# Access Compliance Report

## Public Rights-of-Way

### (Pedestrian Signals)

Intersection ID: N/A	Main Street:	Cross Street: N/A	Location: N/A
ADA ID: FD59A5502B86	Signal Type: Two Push Buttons-Non APS	Overall Compliance: No	Severity Score: BTN 1:N/A BTN 2: N/A No BTN: N/A
Codes/Mitigation Info/Possible Solution		Field Measurements/Component Compliance

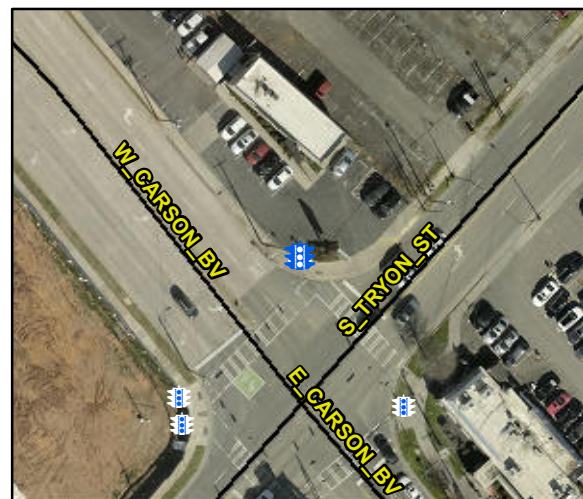
PROW/ADA: TMUTCD 4e.08, R404.1, R404.7.3, R404.2, R406.2

Compliance	Description	Data	Compliance	Description	Data
	Button Count	Button2	N/A	Distant to Additional Button (in)	N/A
	Additional Button Present?	No		Additional Button ID	N/A
N/A	Signal Buttons Required?	N/A	N/A	Additional Ped Posts Required	N/A
	How Many Ped Street Xings?	2		Located In An Island/Median?	No
N/A	B 1 Sign Present?	Yes	N/A	B 2 Sign Present?	Yes
Yes	B 1 Sign Purpose?	Yes	Yes	B 2 Sign Purpose?	Yes
Yes	B 1 Sign Lettering & Contrast?	Yes	Yes	B 2 Sign Lettering & Contrast?	Yes
Yes	B 1 Parallel To XWalk?	Yes	Yes	B 2 Parallel To XWalk?	Yes
Yes	B 1 PAR to Button?	Yes	Yes	B 2 PAR to Button?	Yes
Yes	B 1 PAR to XWalk?	Yes	Yes	B 2 PAR to XWalk?	Yes
No	B 1 Clear Floor Space?	No	Yes	B 2 Clear Floor Space?	Yes
N/A	B 1 FWD Approach?	No	N/A	B 2 FWD Approach?	Yes
N/A	B 1 FWD Approach Constrained?	N/A	N/A	B 2 FWD Approach Constrained?	No
N/A	B 1 FWD Approach Reach (in)	N/A	No	B 2 FWD Approach Reach (in)	5.0

N/A	B 1 FWD Approach Width (in)	N/A	N/A	B 2 FWD Approach Width (in)	N/A
N/A	B 1 FWD Approach Obstruction?	N/A	N/A	B 2 FWD Approach Obstruction?	Yes
N/A	B 1 FWD Approach Obstruction Dist (in)	N/A	N/A	B 2 FWD Approach ObstructionDist (in)	2.0
N/A	B 1 PARA Approach?	Yes	N/A	B 2 PARA Approach?	Yes
N/A	B 1 PARA Approach Constrained?	No	N/A	B 2 PARA Approach Constrained?	No
No	B 1 PARA Approach Reach (in)	11.0	Yes	B 2 PARA Approach Reach (in)	5.0
N/A	B 1 PARA Approach Width (in)	N/A	N/A	B 2 PARA Approach Width (in)	N/A
N/A	B 1 PARA Approach Obstruction?	Yes	N/A	B 2 PARA Approach Obstruction?	Yes
N/A	B 1 PARA Approach Obstruction Dist (in)	7.0	N/A	B 2 PARA Approach ObstructionDist (in)	2.0
N/A	B 1 Clear Floor Space Slope (%)	0.9	Yes	B 2 Clear Floor Space Slope (%)	0.7
N/A	B 1 Clear Floor Space XSlope (%)	4.9	No	B 2 Clear Floor Space XSlope (%)	3.3
N/A	B 1 PAR Slope (%)	0.7	N/A	B 2 PAR Slope (%)	0.8
Yes	B 1 Height (in)	38.0	Yes	B 2 Height (in)	38.0

Yes	B 1 Clear Xing Direction?	ClearlyMarked	Yes	B 2 Clear Xing Direction?	ClearlyMarked
	B 1 Crossing Direction	To SW		B 2 Crossing Direction	To SE
No	B 1 DistanceTo XWalk (in)	118.0	Yes	B 2 DistanceTo XWalk (in)	0.0
No	B 1 DistanceTo Curb (in)	93.0	No	B 2 DistanceTo Curb (in)	91.0
Yes	B 1 Diameter (in)	2.0	Yes	B 2 Diameter (in)	2.0

Possible Solutions: Replace Signal Push Button With APS Button on New Post. Remove & Relocate Sign.
